City of Somerville

URBAN DESIGN COMMISSION

DESIGN REVIEW RECOMMENDATION

59 Bow Street

Applicant's Preferred Schematic Design

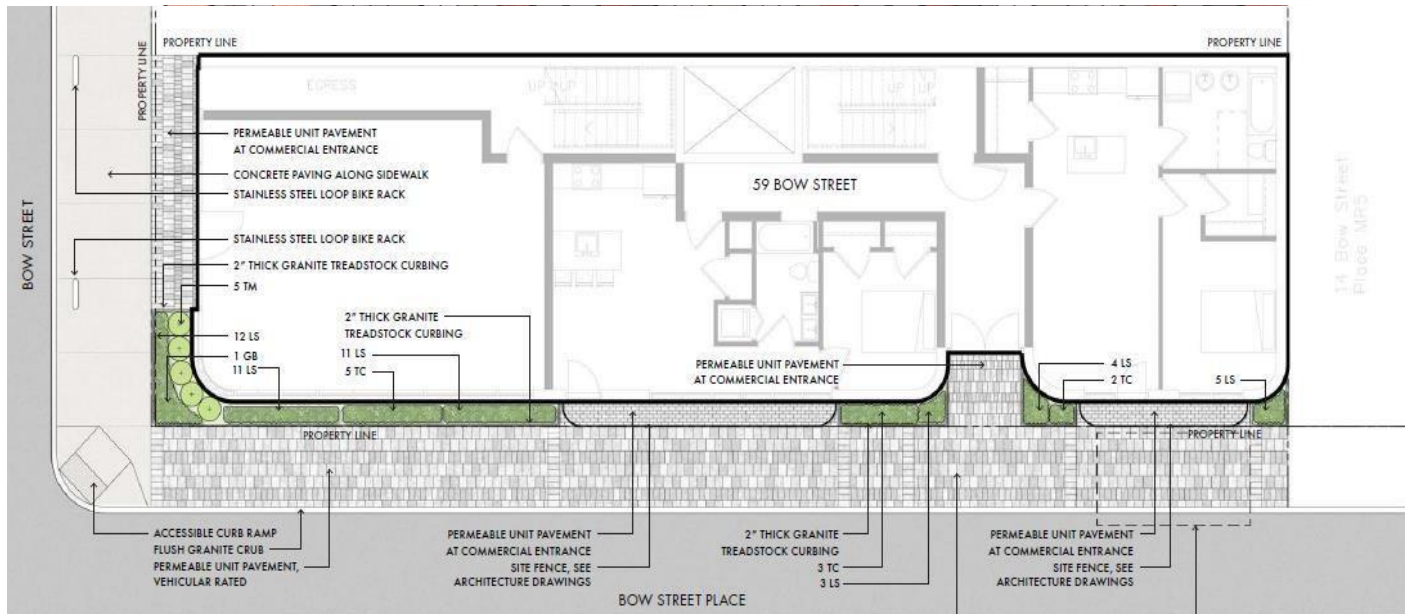
- Explore the possibility of having the ground story landscaping follow the building corner around the curve from Bow St Place to the building primary frontage along Bow St.
- Rethink ground story outdoor space for residential units. Space would integrate better as part of the overall building landscaping.
- The parapet at the top of the building should be enlarged or brought up to provide some screening for mechanical equipment on the roof of the fifth floor.

REMAINING CONCERN Ground Story Landscaping

REMAINING CONCERN Roof Top Equipment Screening
